ADDENDUM NO. 2

To the Drawings and/or the Specifications for
Harford County Public Schools
Harford High School
Comprehensive Roof Replacement – CAG 25-1
Bel Air, Maryland

April 7, 2026

A4.1
 DATE: 03/15/2025

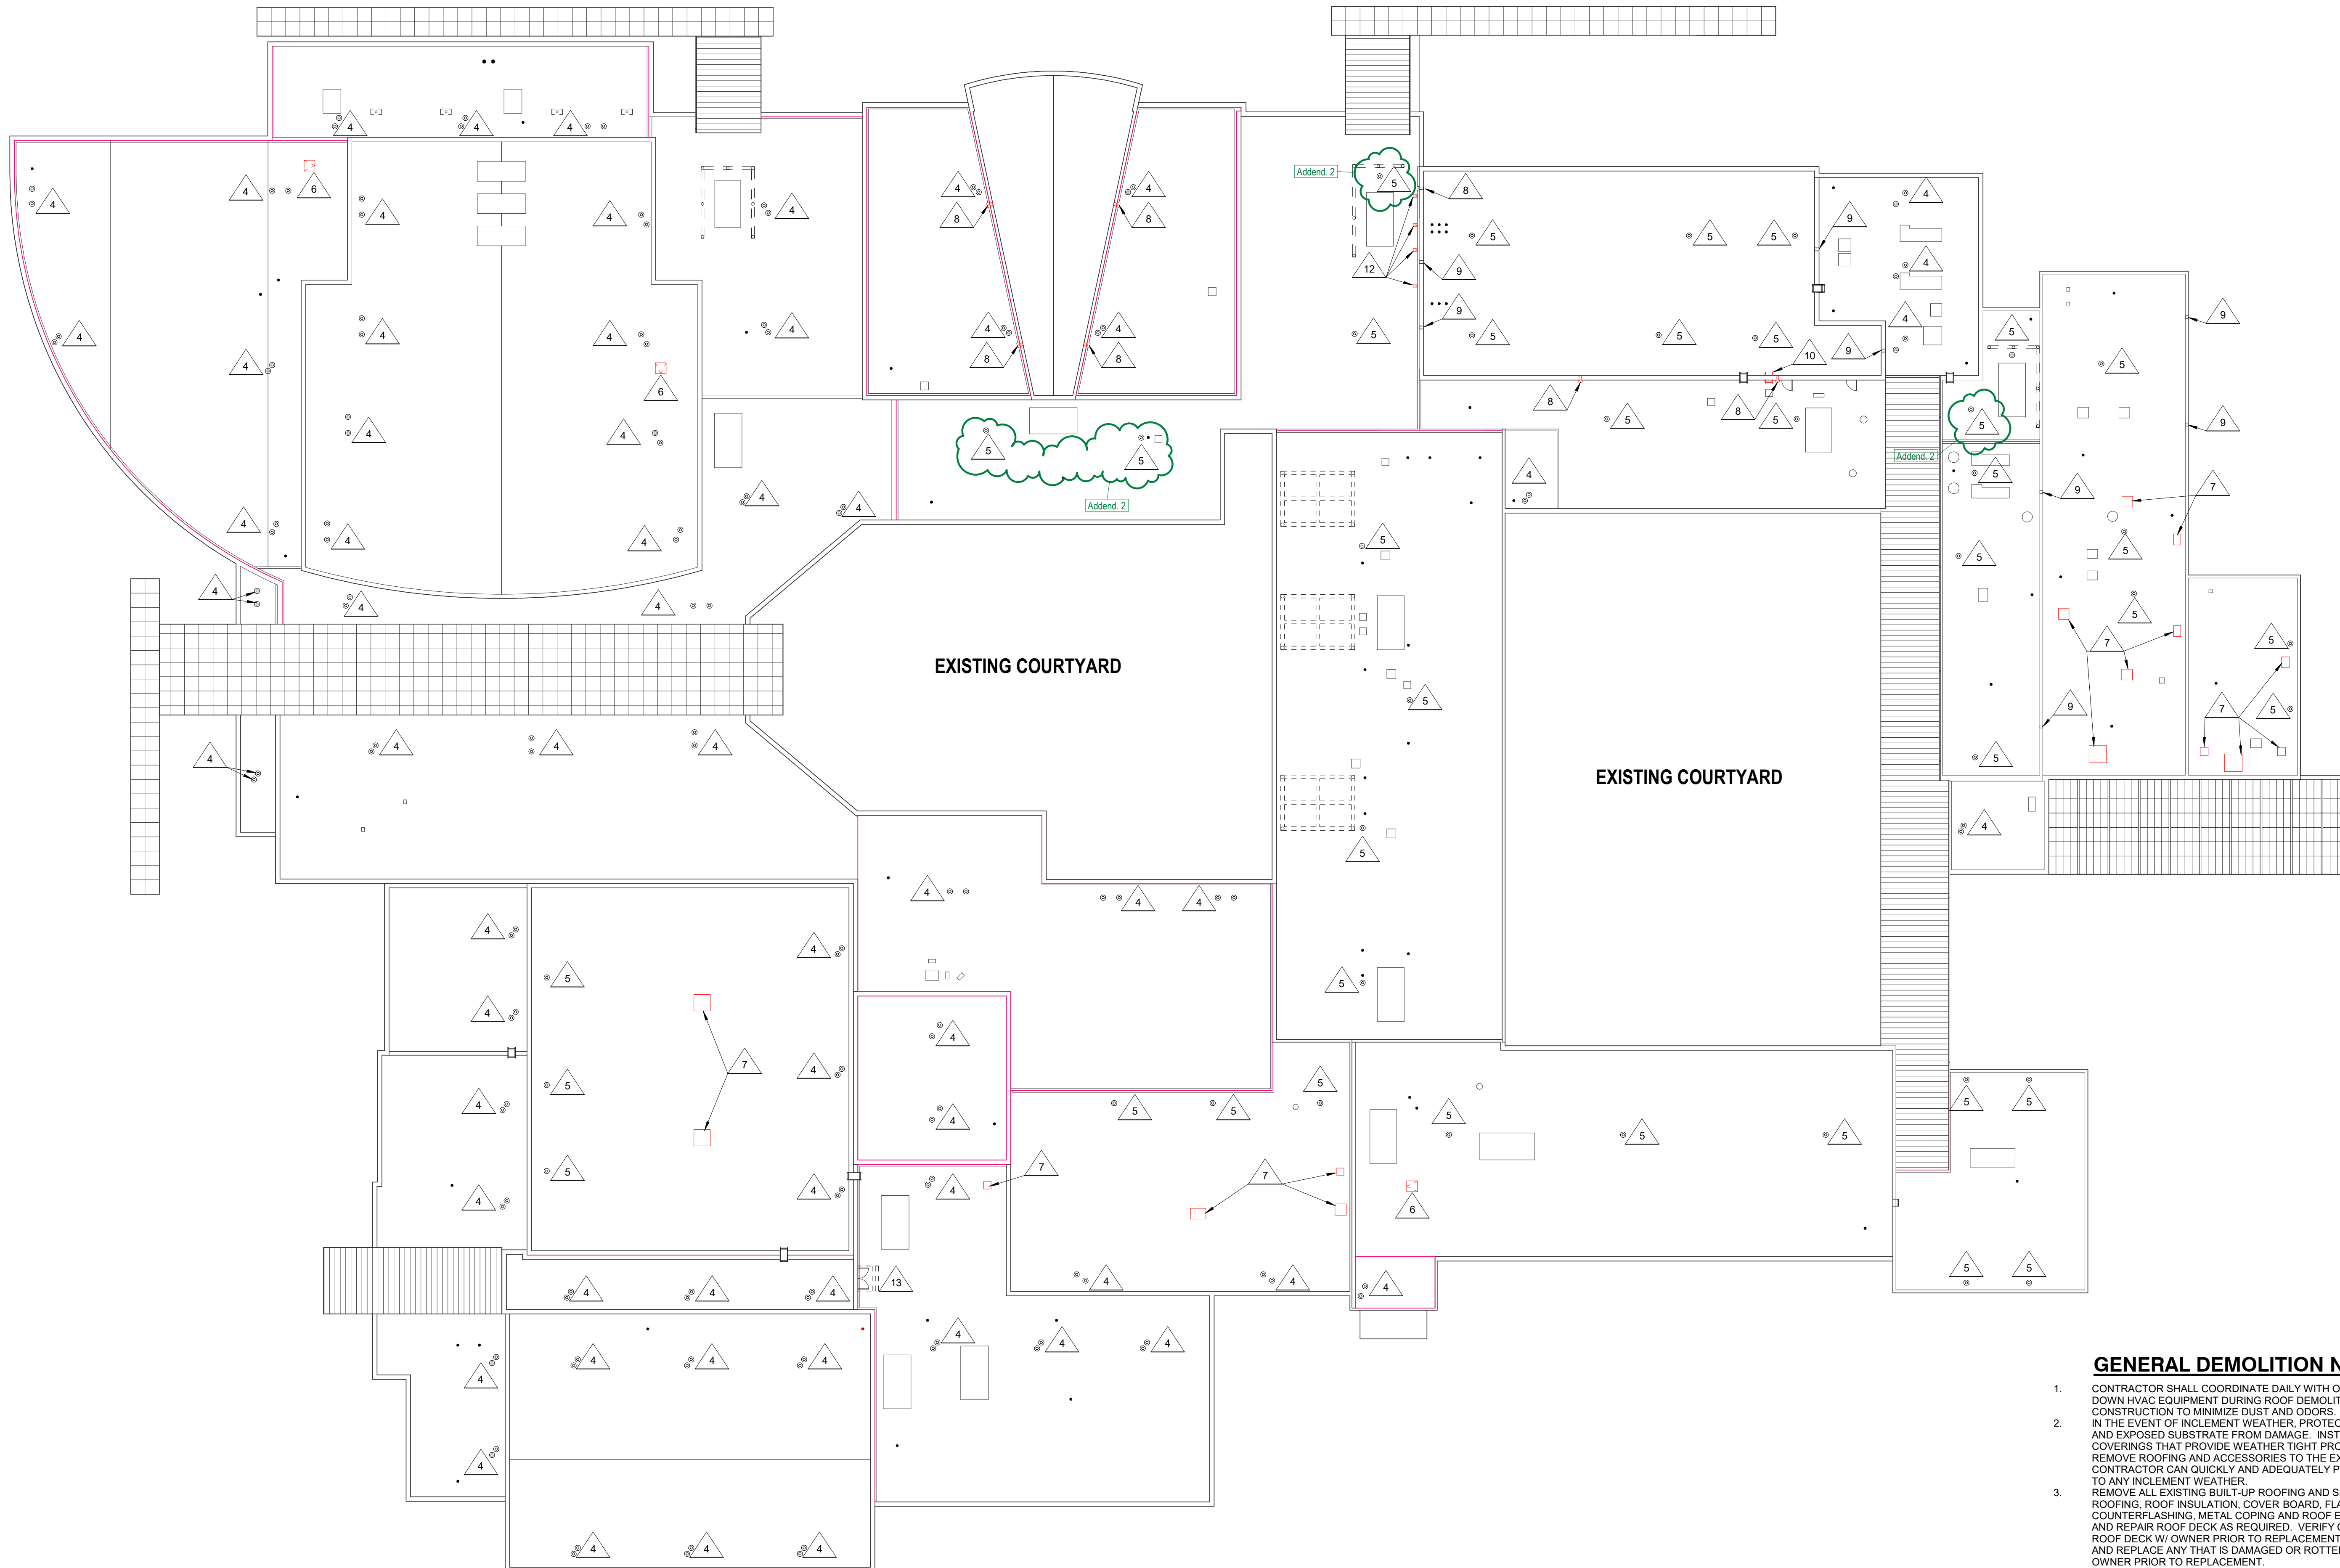
1. Delete “PROGRESS SET” and “NOT FOR CONSTRUCTION” from title blocks of all drawings.
2. SHEETS A4.1 – ROOF PLAN – DEMOLITION and A4.2 – ROOF PLAN, LEGEND, AND NOTES:
RFI Question: “Architectural demolition drawing A4.1 indicates removal of roof drain and overflow pipe. However new work on A4.2 only identifies a new roof drain. Please clarify if overflow drains or overflow pipes are to be installed as part of the new work.
RFI Response: Primary drains that have overflow drains and those that don’t have overflows are identified with different demo tags and notes on the demo drawings, and different roof drain tags and notes on the new work roof plan. Refer to the demolition notes on sheet A4.1, and the roof plan legend on A4.2. There are a few corrections to the roof drains on the demolition drawings and the drains on the new work roof plan. See the revised sheets A4.1 and A4.2 included herein for these corrections.

DRAWN BY: TJA/HOM
PROJECT NO: 2511
SHEET NO:
A4.2
DATE: 03/15/2025

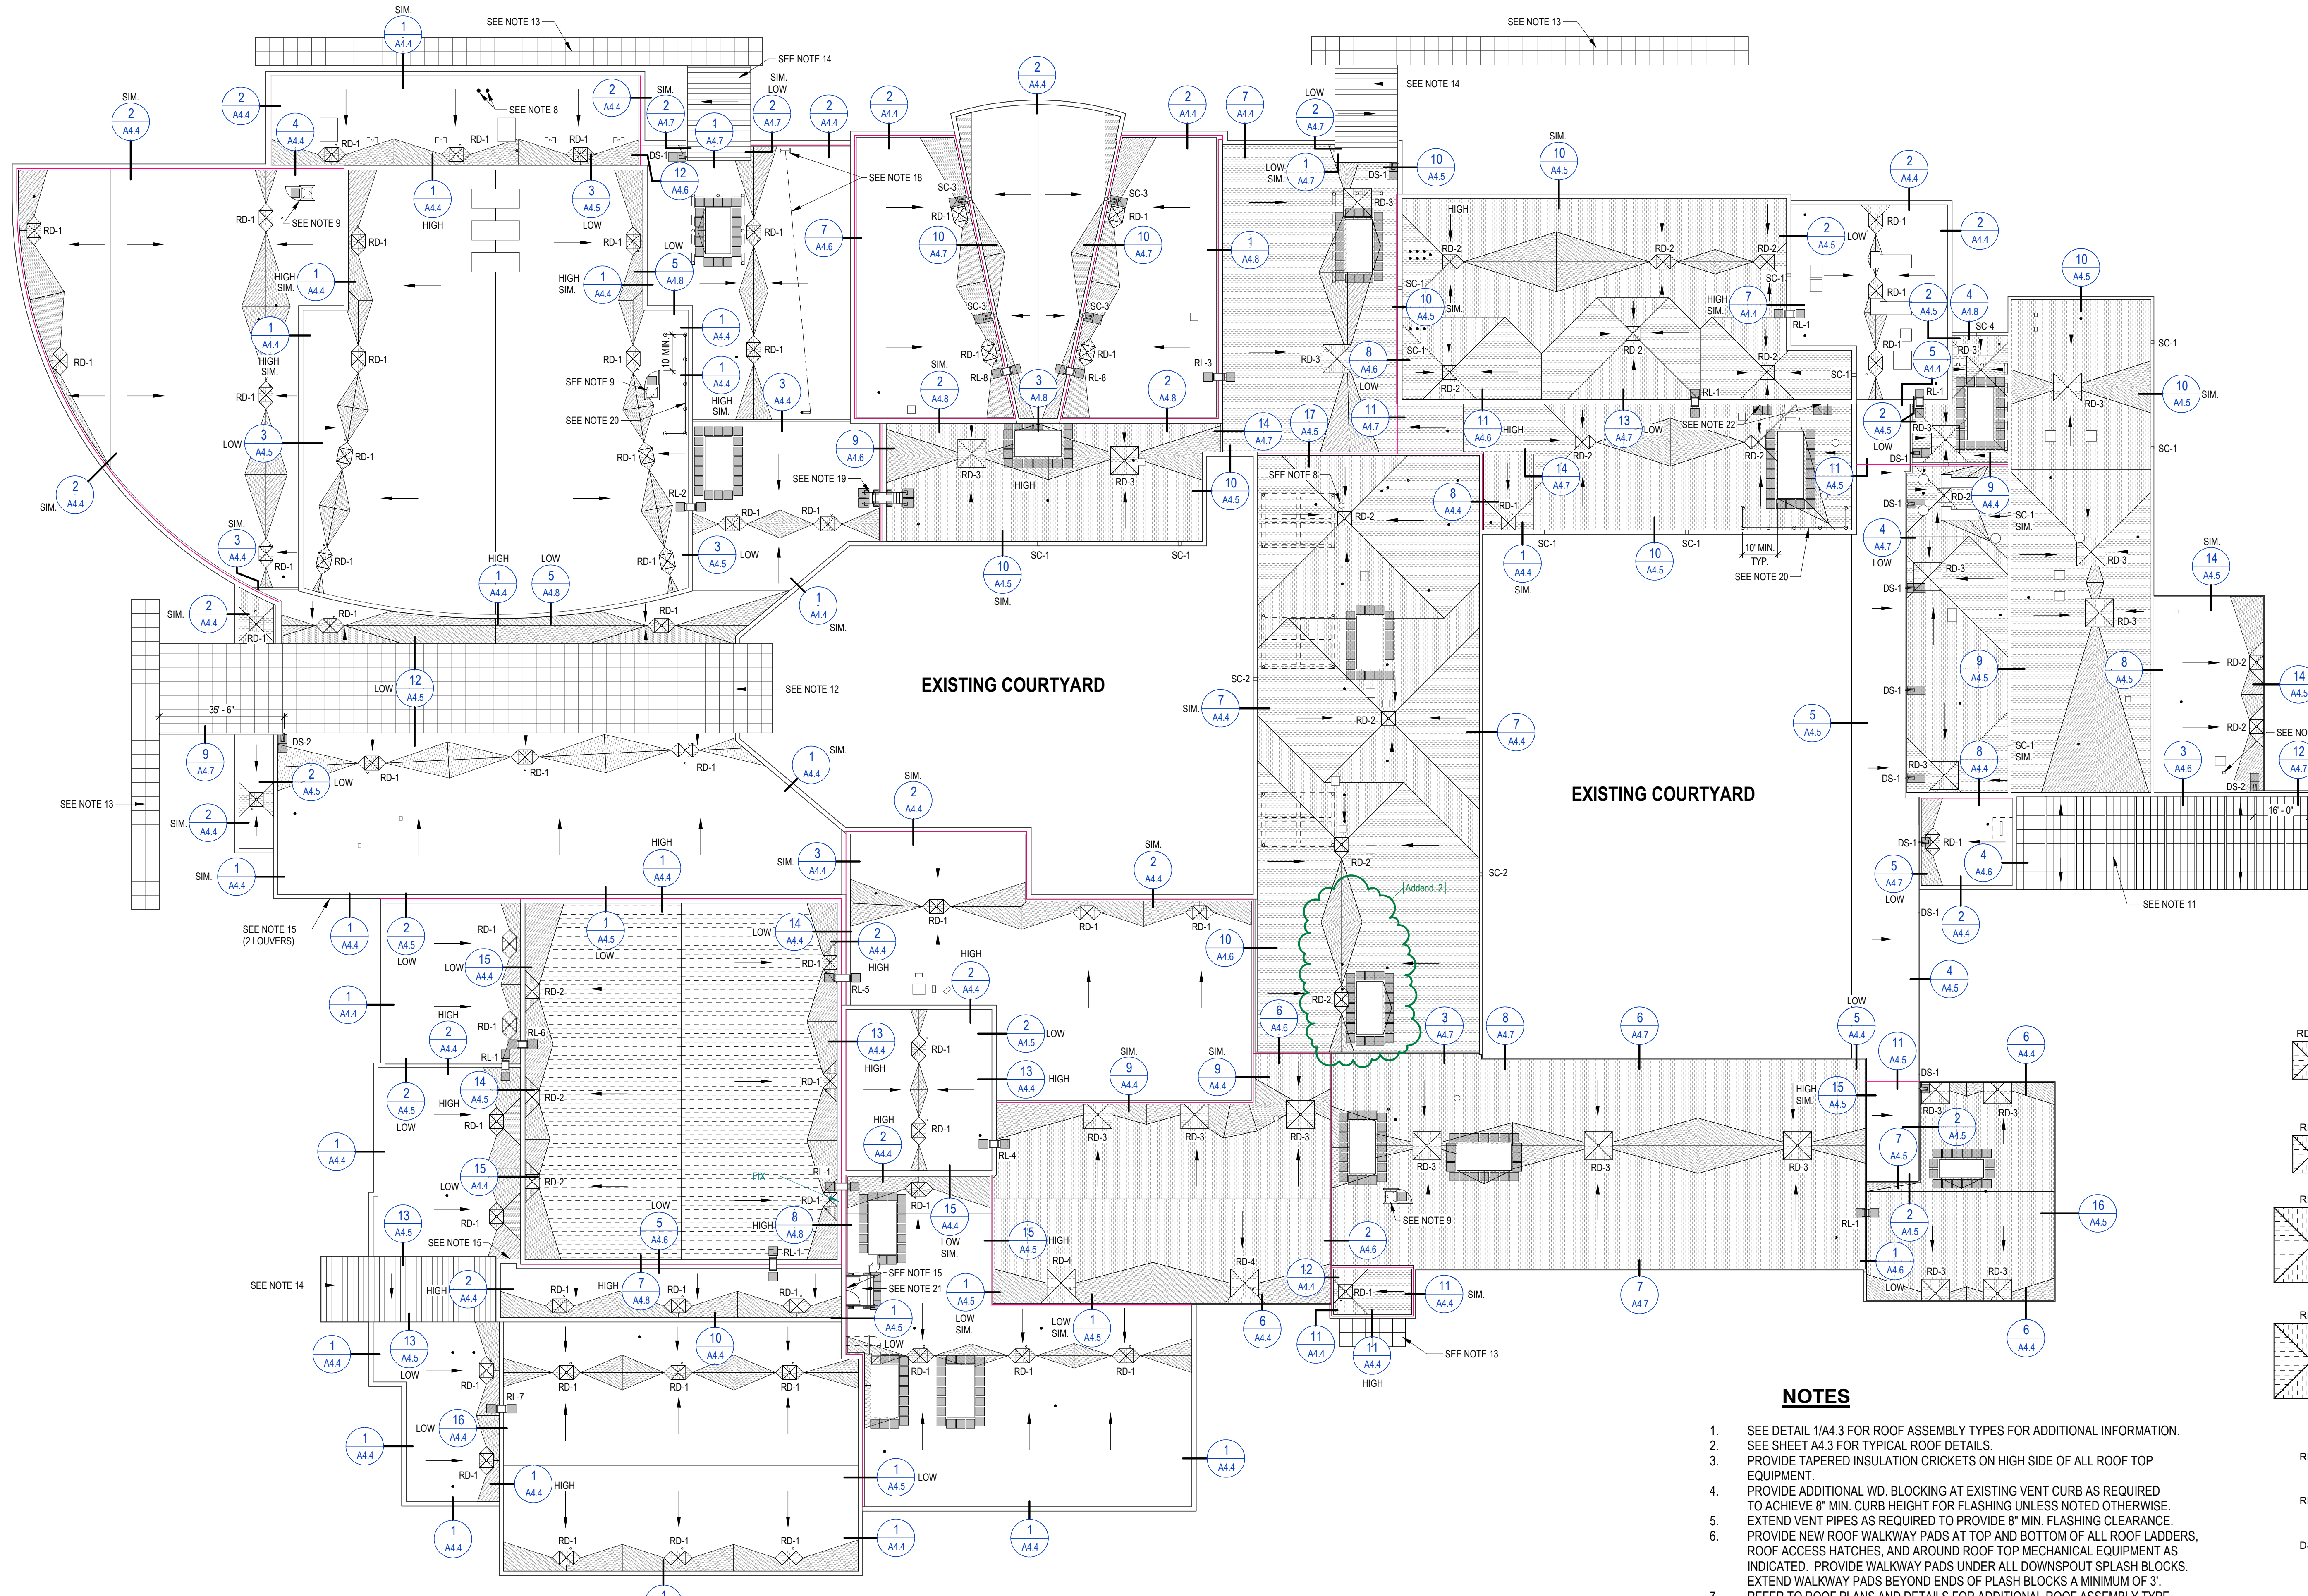
3. **RIF Question:** Is the R Value minimum average per section or average across the project?
RIF Response: Areas of the roof with ¼” per ft. existing sloped structure shall receive a minimum R-30 insulation. Areas of the roof with 1/8” per ft. sloped structure shall receive a tapered layout adding an additional 1/8” per ft. slope to provide an average R-30 R Value. Areas with level roof structure will receive a ¼” per ft. tapered layout to provide an average R-30 R Value. Refer to the manufacturer’s tapered layout on Sheet A4.10 and the roof Assembly Types on Sheet A4.2 for this information.
